From: Hershman, Larry (NHTSA)
Sent: Tuesday, August 30, 2011 2:11 PM
To: Reid, Randy (NHTSA)
Cc: Howell, Rosa (NHTSA); Yon, Scott (NHTSA)
Subject: DP09005 & PE10031 Jeep Grand Cherokee - Pinto submission
Attachments: PE10-031 Docket Submission

From: Clarence Ditlow [cmdiii@autosafety.org]
Sent: Tuesday, August 02, 2011 12:30 PM
To: Borris, Frank (NHTSA); Yon, Scott (NHTSA); Hershman, Larry (NHTSA)
Cc: Michael Brooks
Subject: PE10-031 Docket Submission
Attachments: Pinto Recall.pdf

Re: 1971-1976 Pinto and 1975-1976 Bobcat
Fuel Systems (Except Station Wagons)
Campaign No. 293

Subject: Service Recall 293, Announcement of a Recall of 1971-76 Pinto and 1975-76 Bobcat 2-Door Sedans and 3-Door Runabouts for Fuel System Modifications.

ATTACHMENT II
RECALL 293

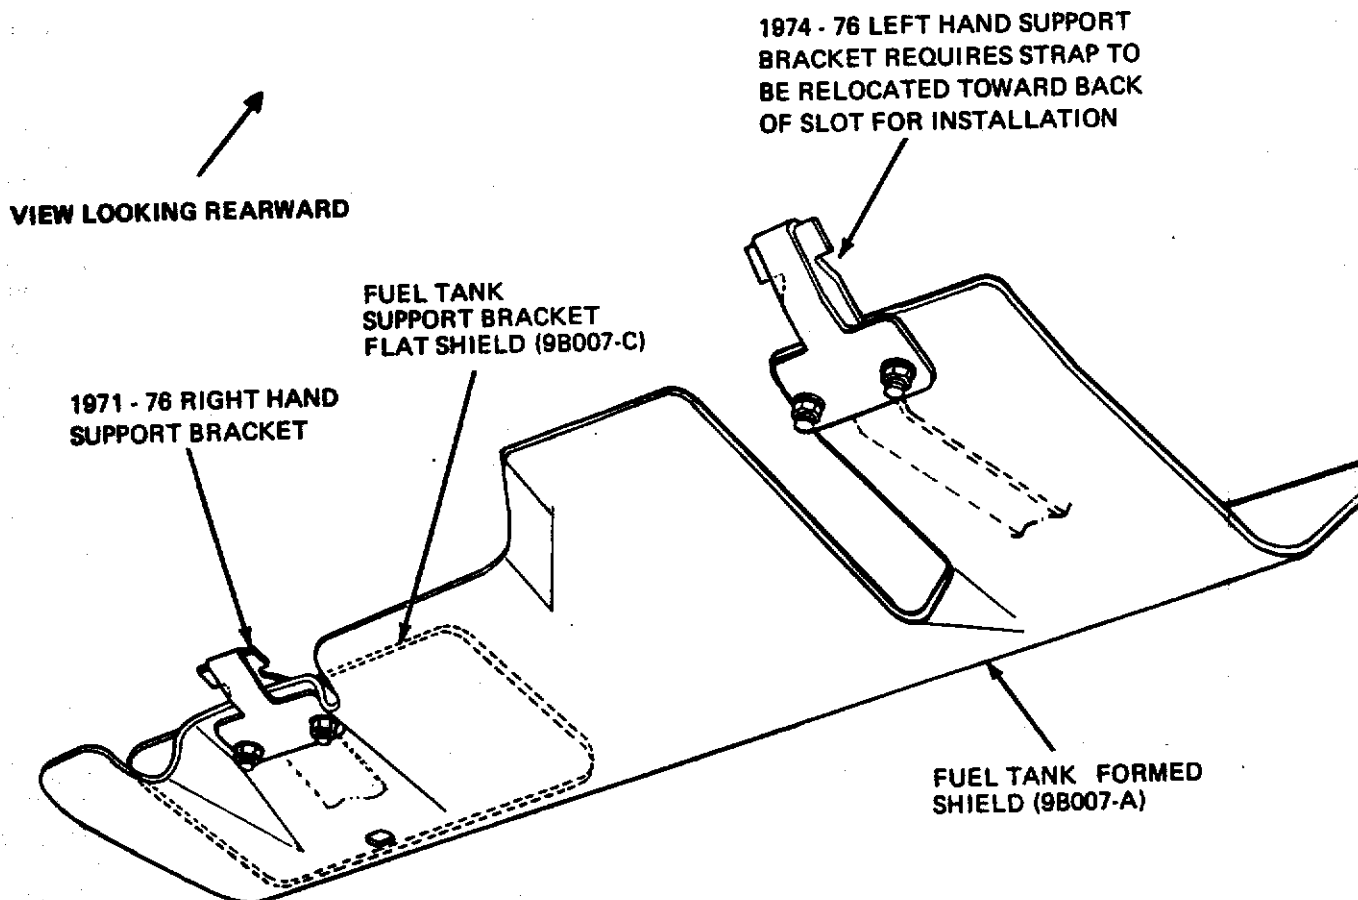
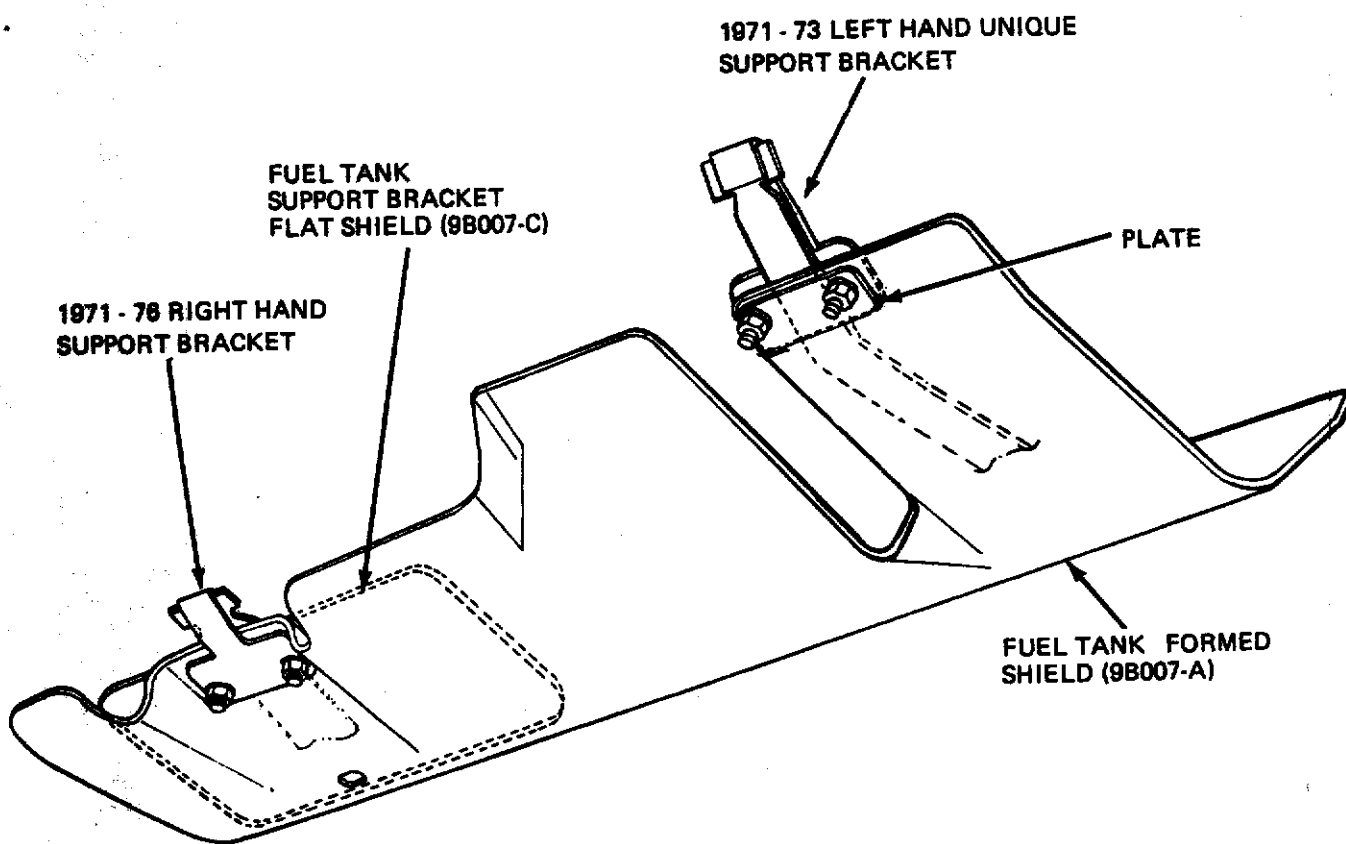
For 1971-73 vehicles - Install the right hand bracket over the fuel tank strap through the slot in the support member with the bracket on the forward side of the strap. Position the flat fuel tank support bracket shield (9B007-C) on the right hand side only as shown in Attachment II. Install the left hand bracket over the end of the strap with the bracket between the tank and strap. Install the U-bolt through the left hand bracket from the rear of the bracket. Install the formed fuel tank shield (9B007-A) on the left hand U-bolt holes as indicated on the shield. Install plate on left hand U-bolt and thread nuts. Complete the installation as shown in Attachments II, III and IV by installing the U-bolt around the rear of the right hand strap and through the shield and bracket (no plate required for right hand U-bolt).

For 1974-76 vehicles - Install the right and left hand brackets on the forward side of the strap as shown in Attachment II. The left hand strap must be pushed toward the back of the slot to allow installation of the bracket. Position the fuel tank support bracket shield (9B007-C) on the right hand side only as shown in Attachment II. Install the fuel tank shield (9B007-A) as shown in Attachments II and III, using the left hand holes indicated for 1974-76 (the 9B223 plate is not used for shield installation on these vehicles).

NOTE: PROPER LOCATIONS OF BRACKETS ON SHIELD AFTER SHIELD IS INSTALLED
(FOR REFERENCE ONLY)

1971 - 1976 RIGHT HAND FUEL TANK SHIELD
SUPPORT INSTALLATION

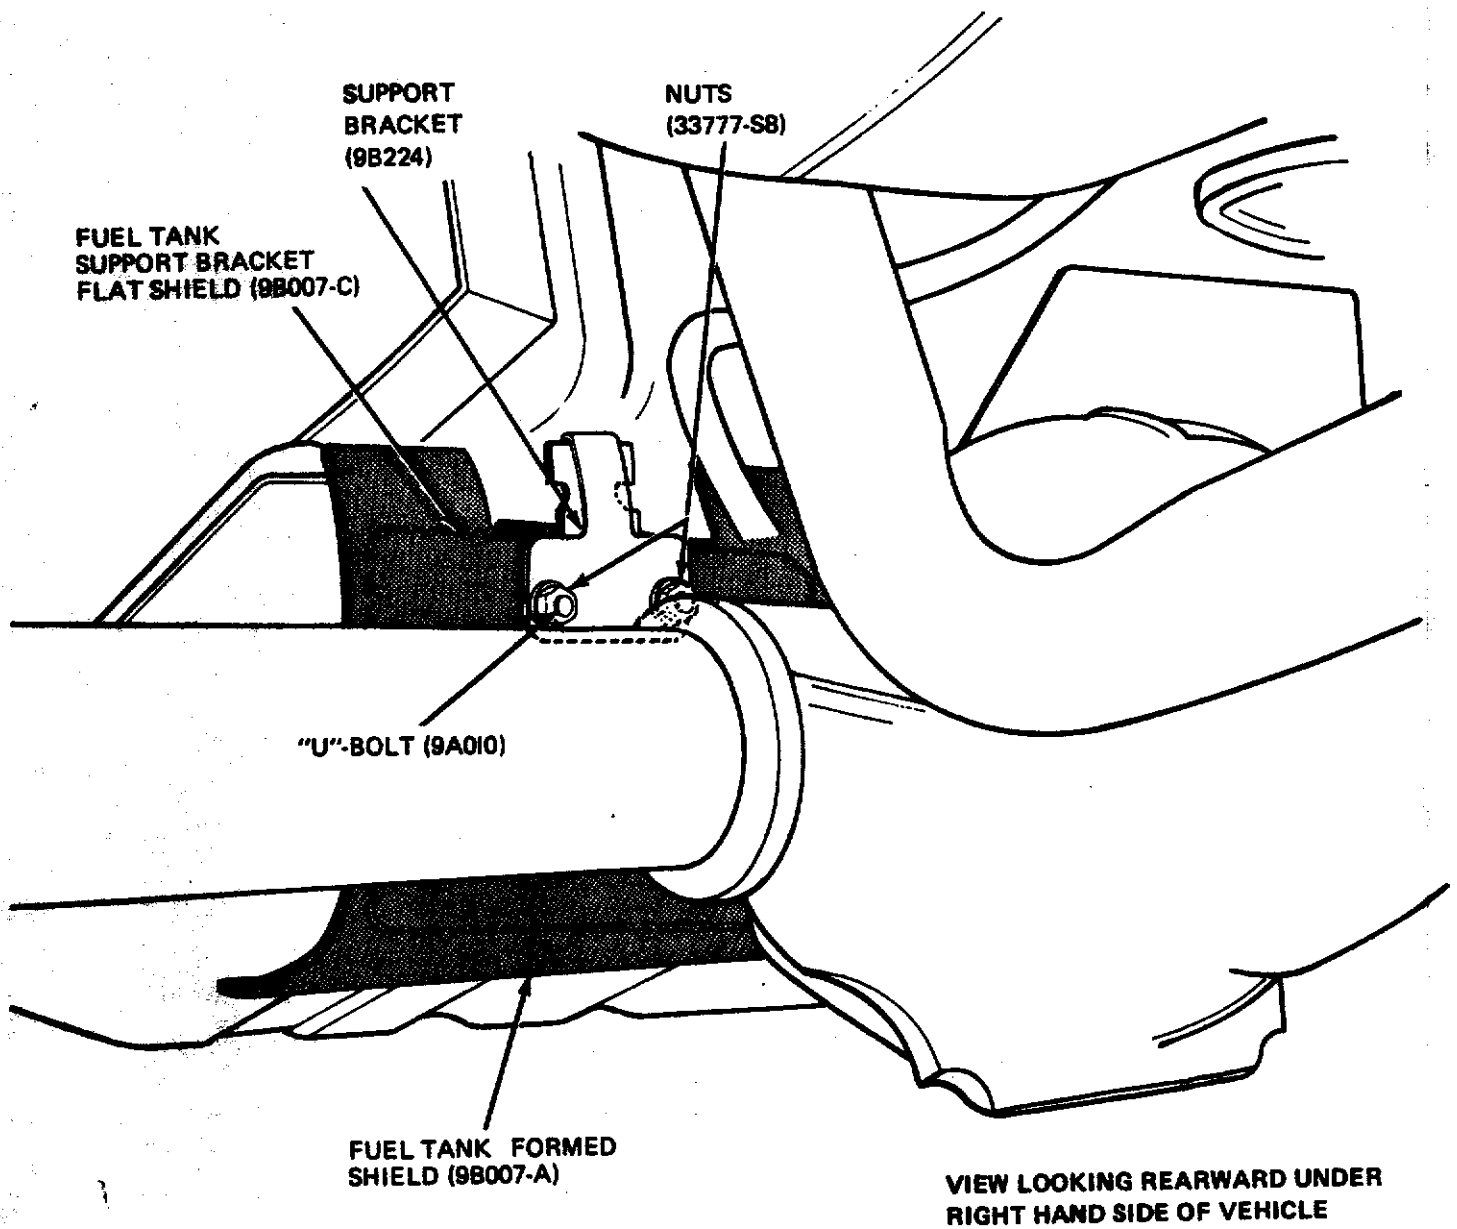
NOTE: 1975 vehicles with dual exhaust require a unique fuel tank shield (9B007-A) as shown in Attachment V. On all 1971-76 vehicles the fuel tank support bracket shield (9B007-C) is installed on the right hand side only and between the fuel tank strap and fuel tank shield (9B007-A).

**ATTACHMENT VI
RECALL 293**

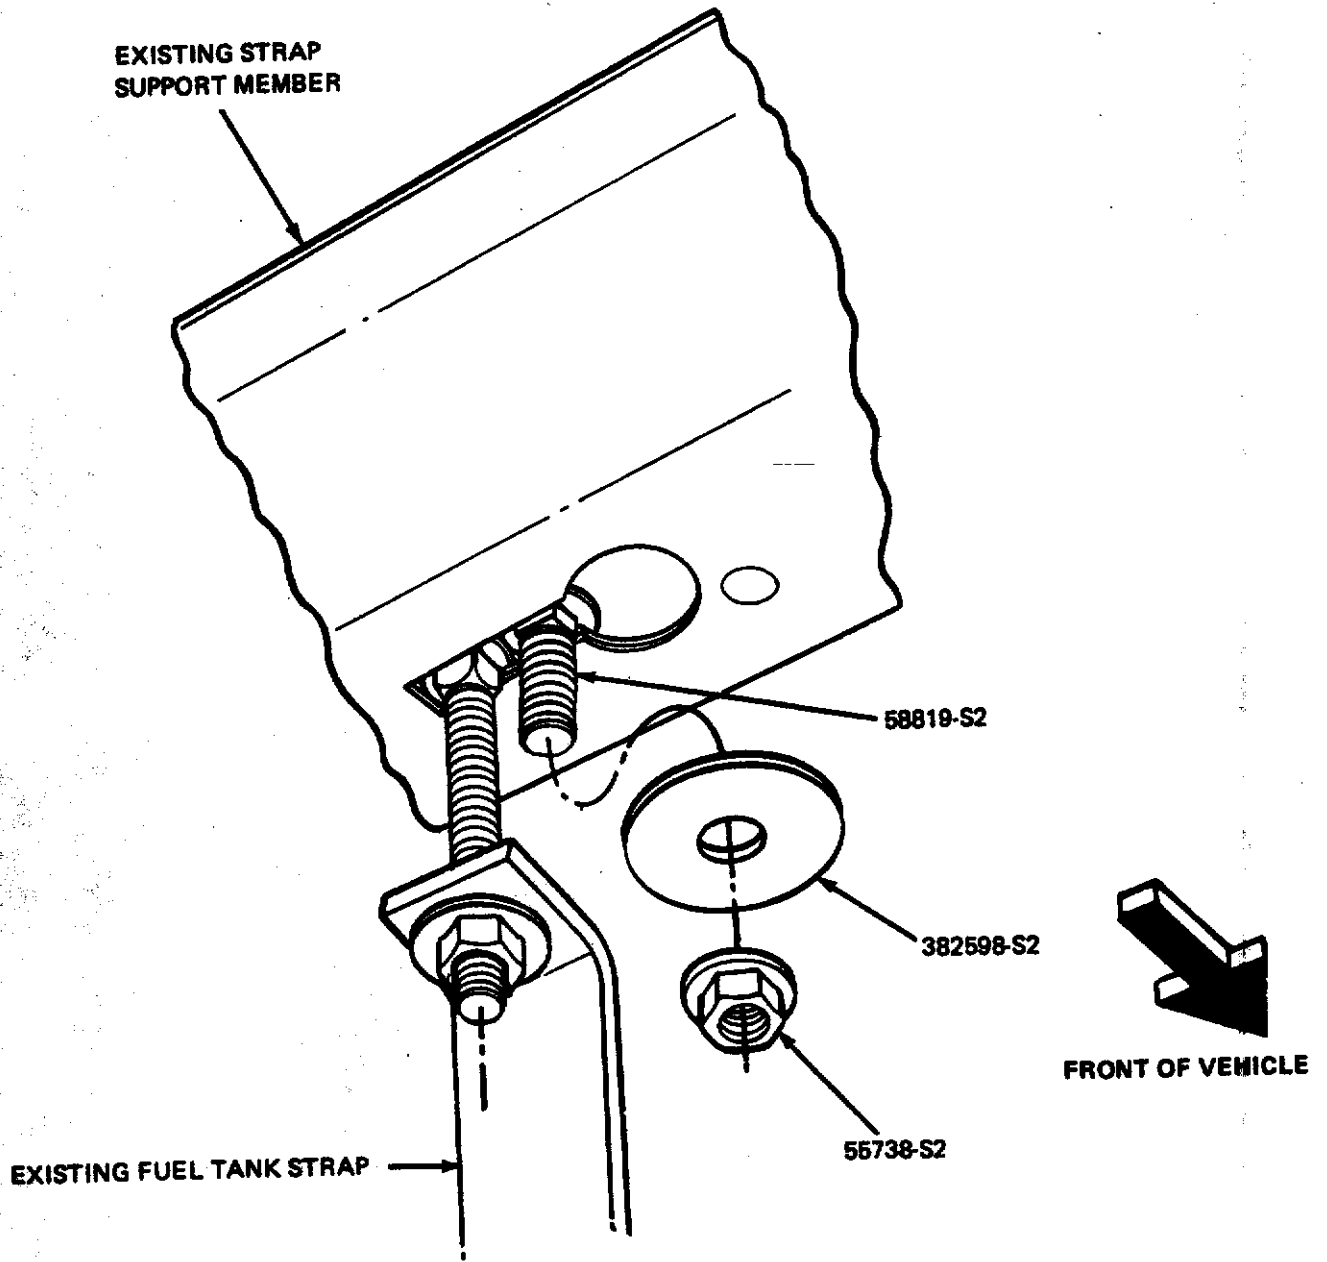
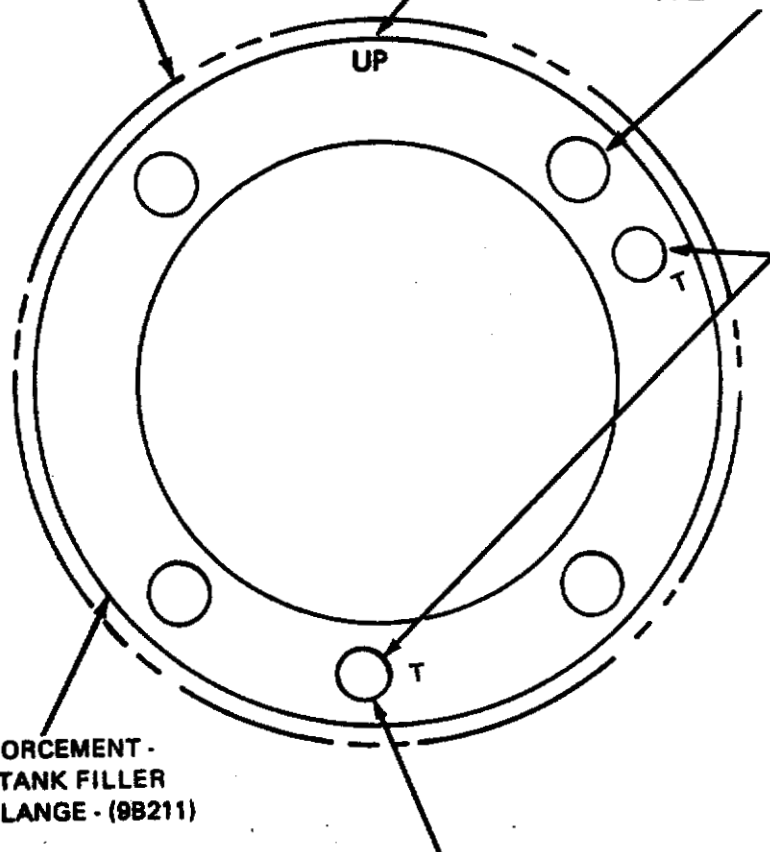
4. Attach bolt service part number (58819-S2), flat washer service part number (382598-S2) and nut service part number (55738-S2) to the strap support member on the left hand side of 1971-73 vehicles. On 1974-76 vehicles the above bolt, washer and nut are attached to both right hand and left hand sides of support member. Refer to Attachment VI.

4. To contain fuel vapors and to keep the fuel tank clean, place body tape over the opening in the tank to seal it completely.
5. Align the (2) holes identified with "T" in the reinforcement (9B211) with (2) of the (3) existing holes in the fuel filler pipe opening in the quarter panel. The word "UP" should be visible from outside the vehicle and indexed as indicated in Attachment VIII. Install (2) of the (3) existing 9/32" sheetmetal screws removed in Step 3 above to hold the reinforcement in place.

6. Drill (4) 5/16" diameter holes in the quarter panel using the reinforcement as a template. If fuel vapors are present, DO NOT use electric drill until vapors can be dispersed.

ATTACH REINFORCEMENT
(9B211) TO QUARTER PANEL
OPENING WITH EXISTING
SCREWS AT HOLES
MARKED "T" - 2 PLACES.

DRILL (4) 5/16" DIAMETER
HOLES USING REINFORCE-
MENT AS A TEMPLATE

FUEL TANK FILLER
PIPE SEAL (9072)

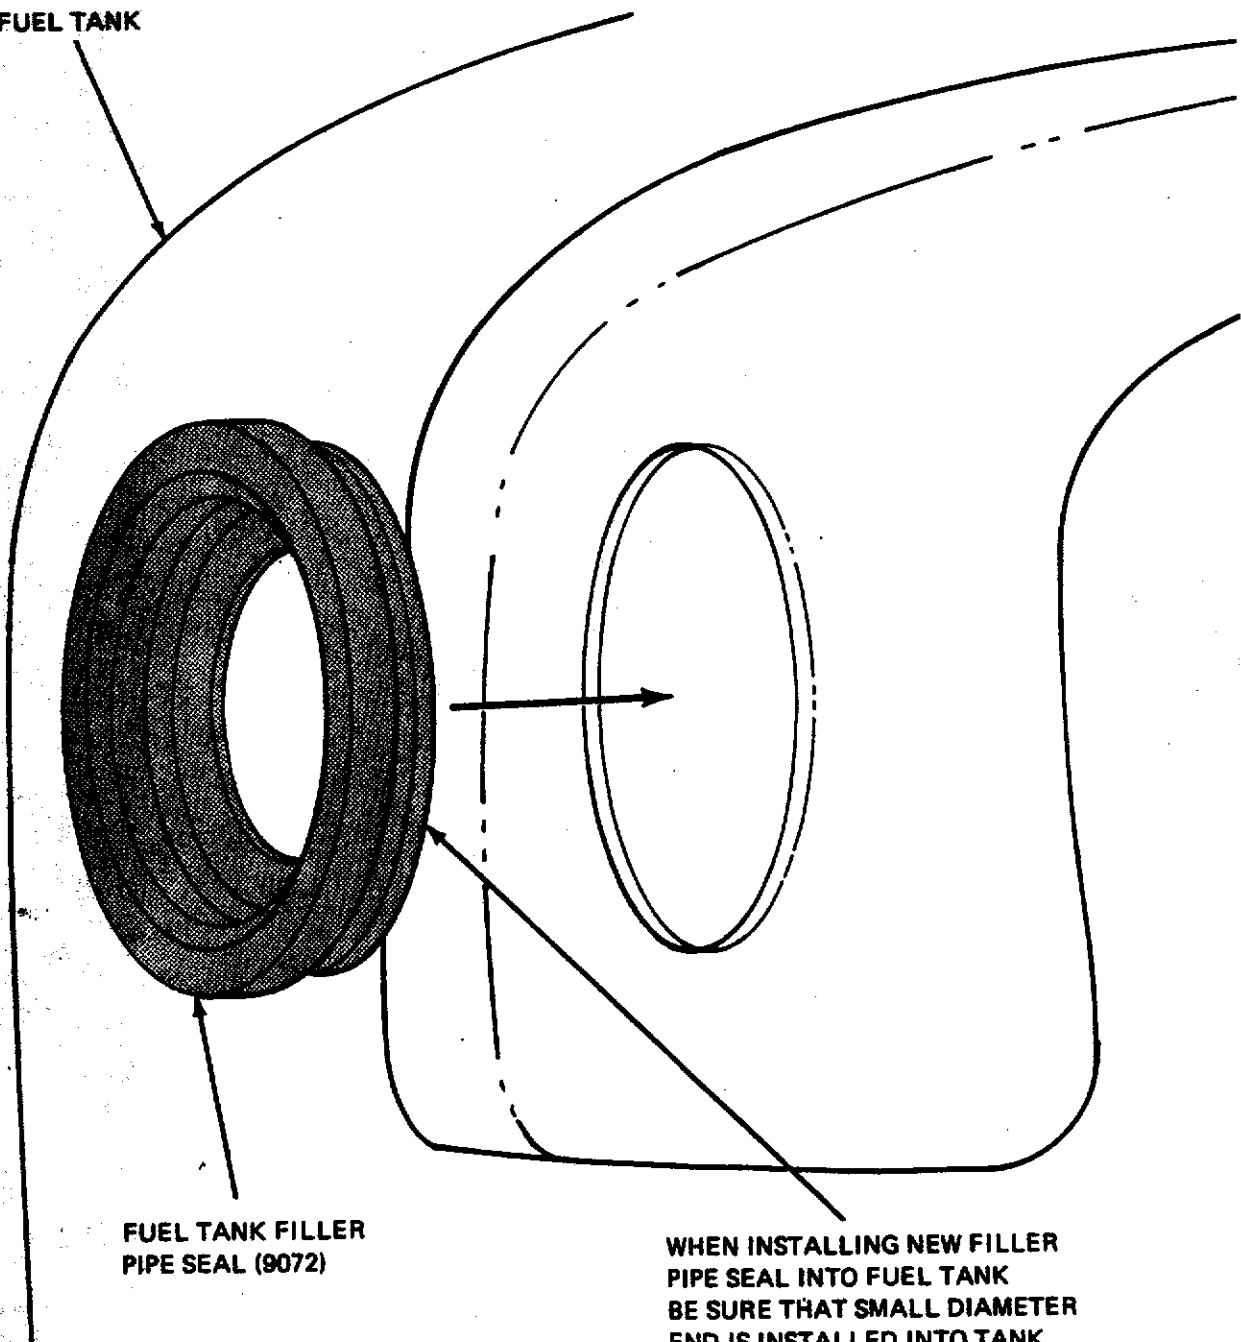
WHEN INSTALLING NEW FILLER
PIPE SEAL INTO FUEL TANK
BE SURE THAT SMALL DIAMETER
END IS INSTALLED INTO TANK.

NEW DIAPHRAGM
AND CUP ASSEMBLY
9B075

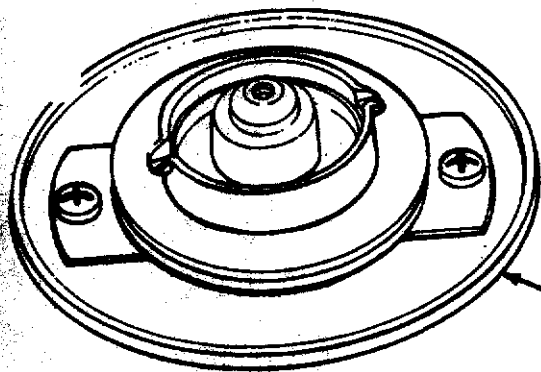
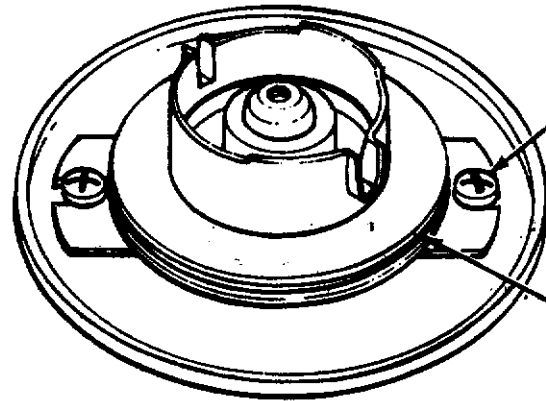
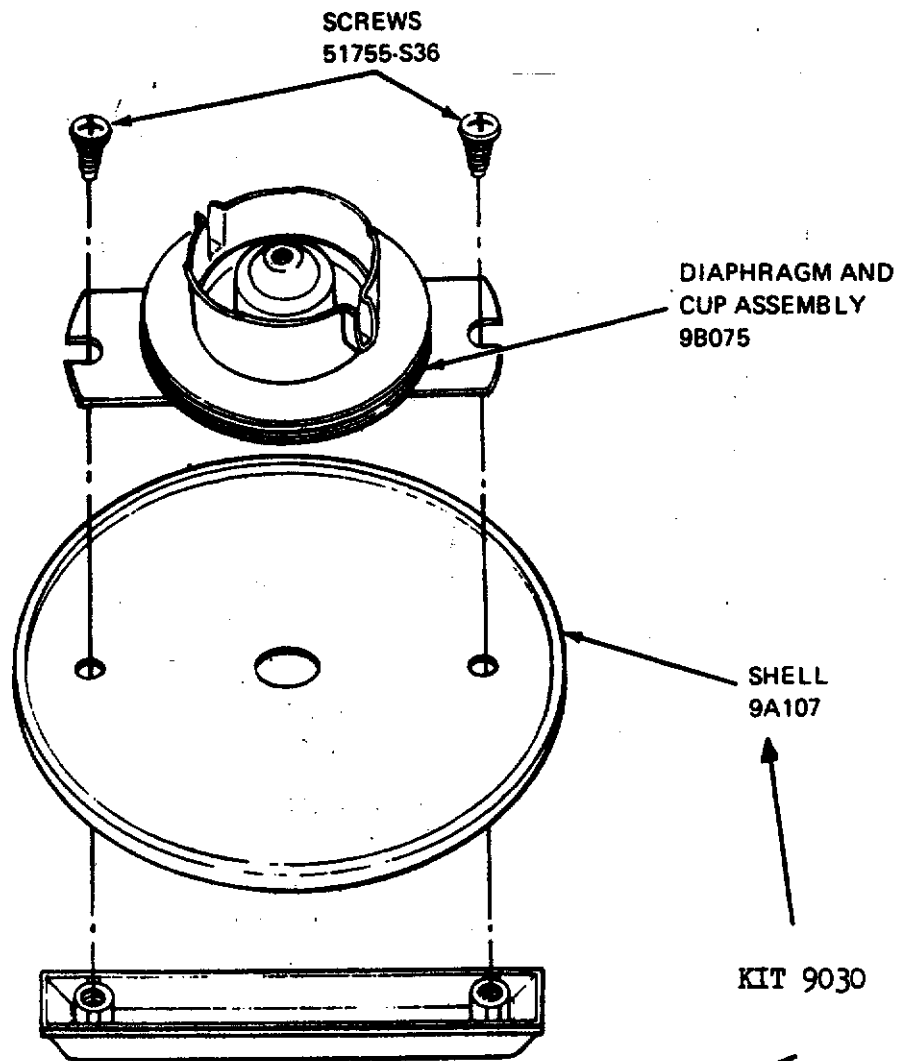
For non-locking original equipment fuel filler pipe cap replacements, (see Attachment IX), remove the (2) existing screws which attach the diaphragm and cup assembly, and install the new diaphragm and cup assembly (9B075) in the existing shell using (2) new screws (51755-S36).

If the cap is a locking or other aftermarket cap, it is to be replaced. (See Attachment IX). Remove the cap from the filler pipe and place it in the passenger compartment of the vehicle. Assemble the new diaphragm and cup assembly (9B075) to the new filler cap shell and handle kit (9030).
